**SUSQUEHANNA STEAM ELECTRIC STATION
PROPOSED LICENSE AMENDMENT NO. 285 FOR
UNIT 1 OPERATING LICENSE NO. NPF-14 AND
PROPOSED LICENSE AMENDMENT NO. 253 FOR
UNIT 2 OPERATING LICENSE NO. NPF-22 EXTENDED
POWER UPRATE APPLICATION RE: REACTOR SYSTEMS
TECHNICAL REVIEW REQUEST FOR ADDITIONAL
INFORMATION RESPONSES**

PLA-6264 **Docket Nos. 50-387**
and 50-388

**Attachment 2 to PLA-6264
Non-Proprietary Version of the Request for
Additional Information Responses**

**Figure A.5 Liquid Velocity at Exit of Average Core
0.05 FT2/PD SF-BATT TOP 108F CPPU**

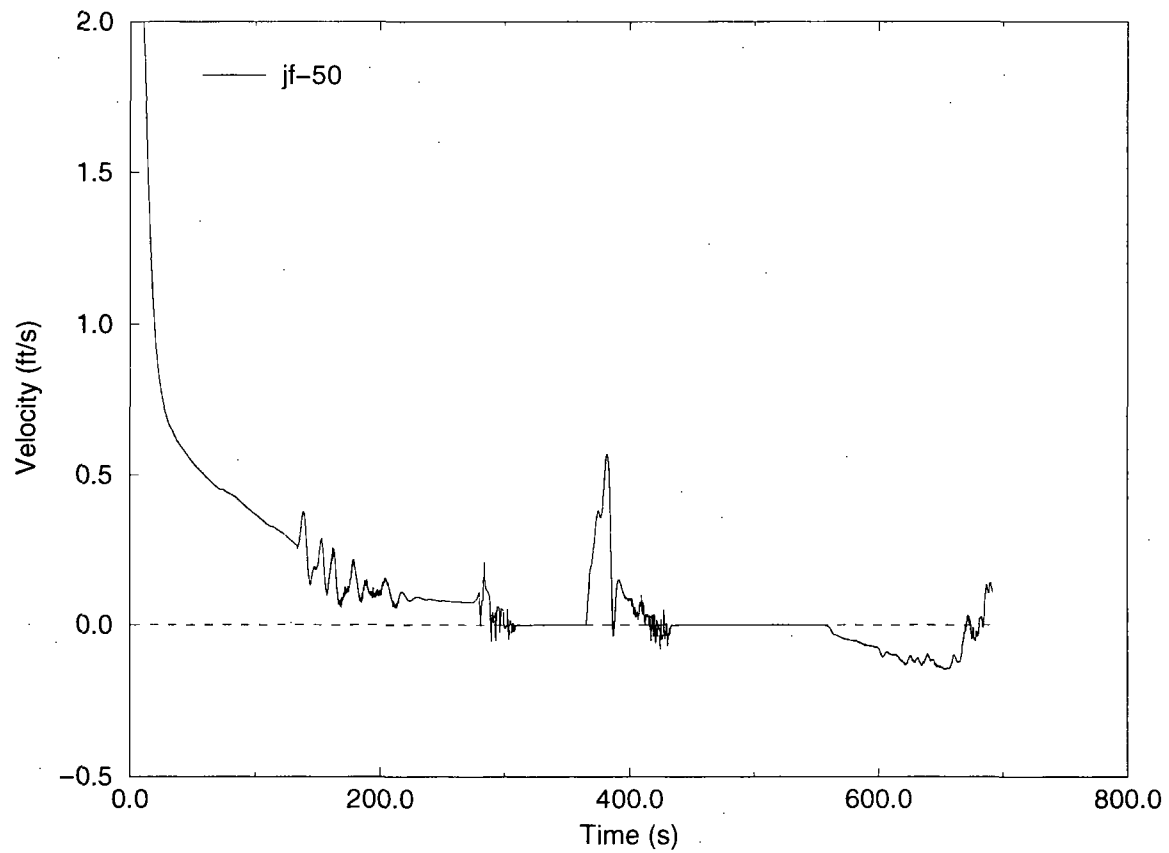
Provide plots of the liquid and vapor velocities at the exit to the core average and hot bundle regions. Also, mass flow into the hot bundle.

The requested liquid and vapor velocity plots are provided in Figures A.5 – A.8. The definition of superficial velocity used here is the velocity an individual phase would have if the entire flow region were filled with the selected phase at the predicted volumetric flow rate for that phase.

**Figure A.10 Liquid Mass in the Core Average Nodes
0.05 FT2/PD SF-BATT TOP 108F CPPU**

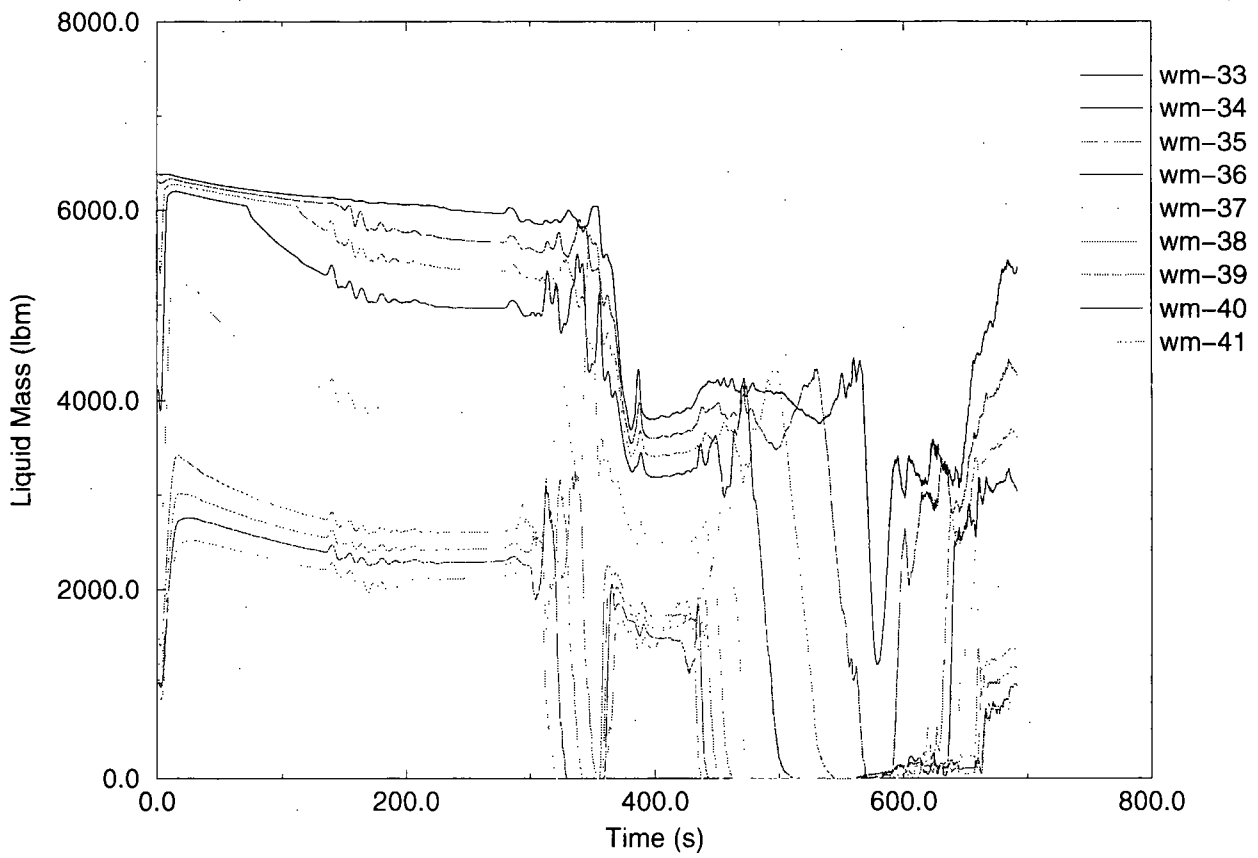
Provide the liquid levels and two phase levels in the core average and hot bundle regions.

The requested data is not available since the core volumes are homogeneous nodes. However, in response to the NRC request, the liquid mass in each of the core average and hot bundle core nodes is provided in Figures A.10 and A.11. These figures illustrate how liquid moves through the core average and hot bundle core nodes during the LOCA.

**Figure A.12 Liquid Velocity at Inlet to Core Bypass
0.05 FT2/PD SF-BATT TOP 108F CPPU**

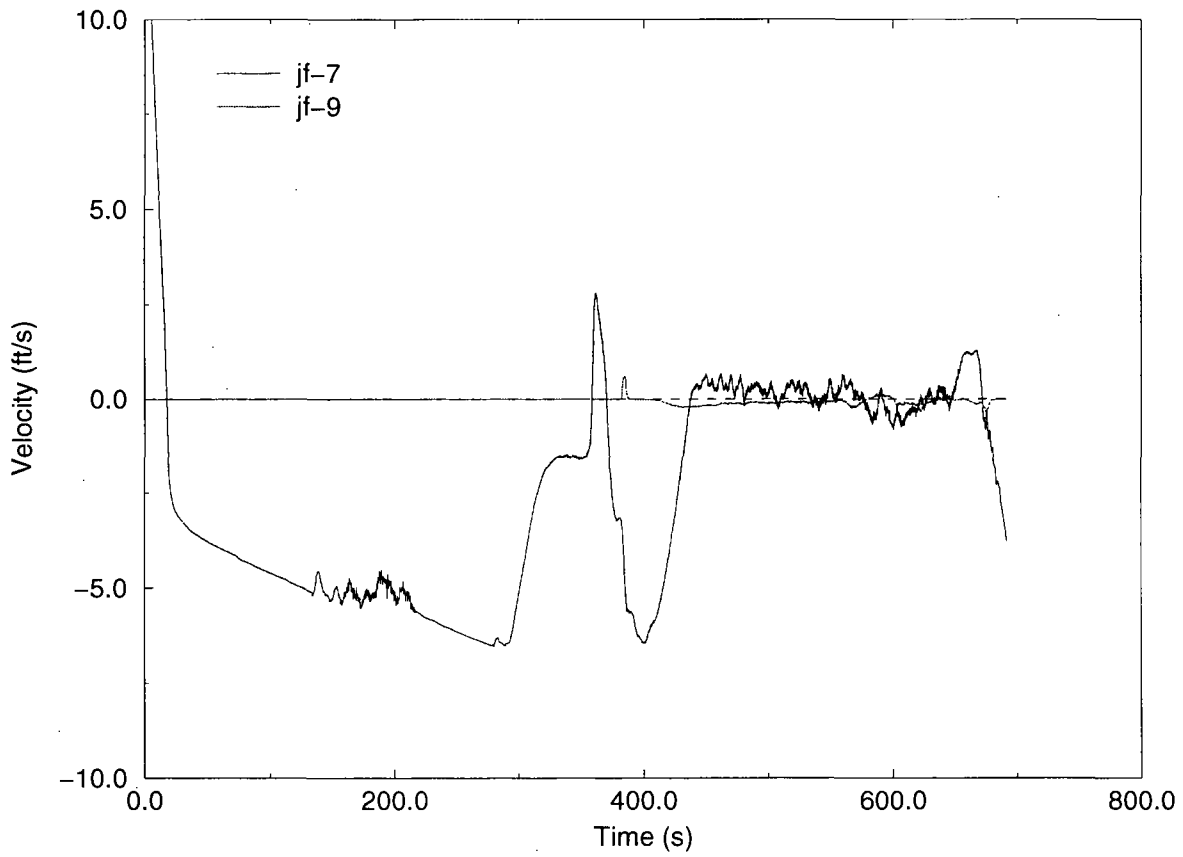
Provide the steam and liquid velocities at the inlet and outlet to the core bypass region.

The requested plots are provided in Figures A.12 – A.15.

**Figure A.16 Liquid Mass in the Hot Channel Nodes
0.05 FT2/PD SF-BATT TOP 108F CPPU**

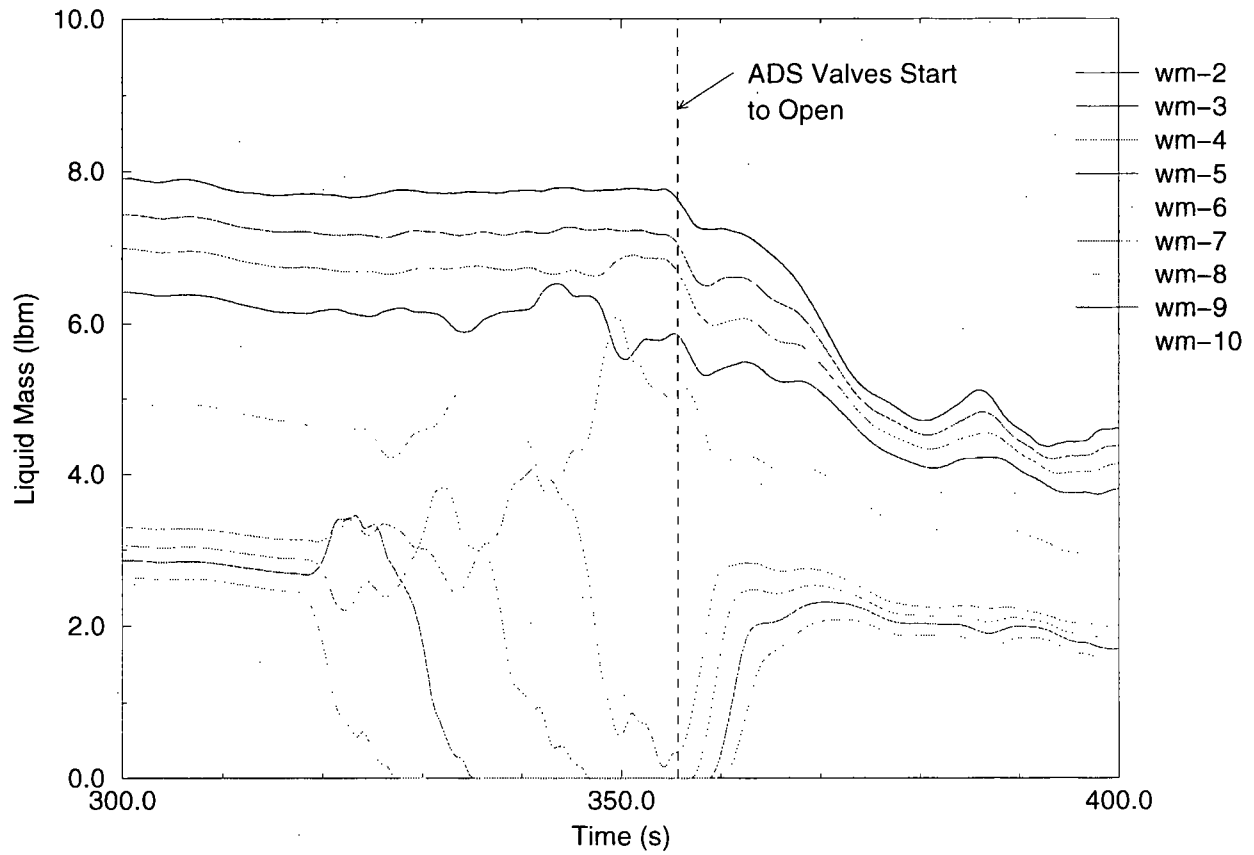
The heat up period before the safety injection is expected to be longer than shown in the SSES 1 and 2 limiting node quality plot (Figure A.24). Additionally, the quality stays lower than expected (about 0.06) for about 110 seconds (365 seconds to 475 seconds) before the heat up, and the heat up time before LPCS starts is about 83 seconds. It is expected that the heat up would be significantly longer and thus, the PCT would be higher than reported in the SSES 1 and 2 analyses. Since it is a top-peaked profile, the quality (void fraction) before heat up seems to be low and heat up time seems to be short. Please provide justification for the low limiting node quality and the short heat up time. If this is related to the modeling of LPCS cooling and CCFL, include this reasoning in your justification.

The decrease in the limiting node quality at about 365 seconds is in response to the rapid system depressurization resulting from opening the ADS valves at 355.7 seconds. The lower plenum begins to flash at 360.2 seconds. As illustrated in Figure A.16, opening the ADS valves caused the liquid mass in upper core nodes to increase (nodes 7, 8, 9, and 10). The decrease in the limiting node quality is due to the increase in the liquid mass in the node. The increase in liquid mass in the upper nodes results from the level swell associated with rapid system depressurization.
